SERVICE BULLETIN

Subject: Incorrect Vector Global Audio Wiring Diagram

Bulletin No. SB05-4

*Incorrect Diagram
Figure 1*

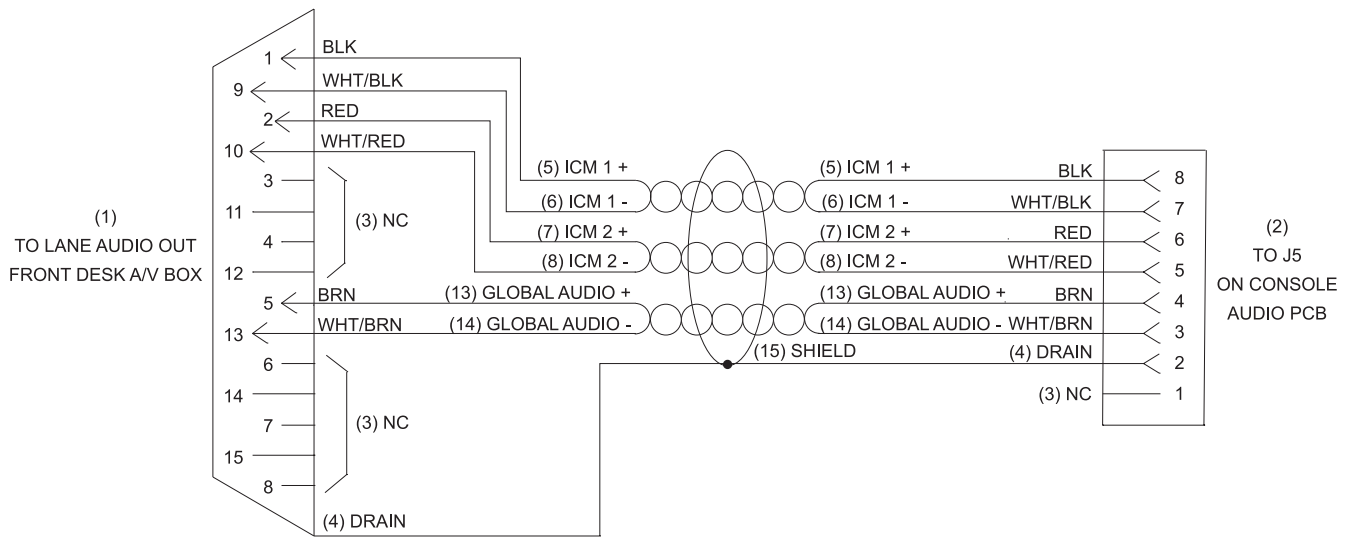
It has come to our attention that the Global Audio wiring diagram on page 56 of the Vector Scorer Service Manual, part number 57-900621-000, is incorrect. Figure 1 shows the incorrect diagram and Figure 2 shows the correct diagram.

Correct Diagram
Figure 2
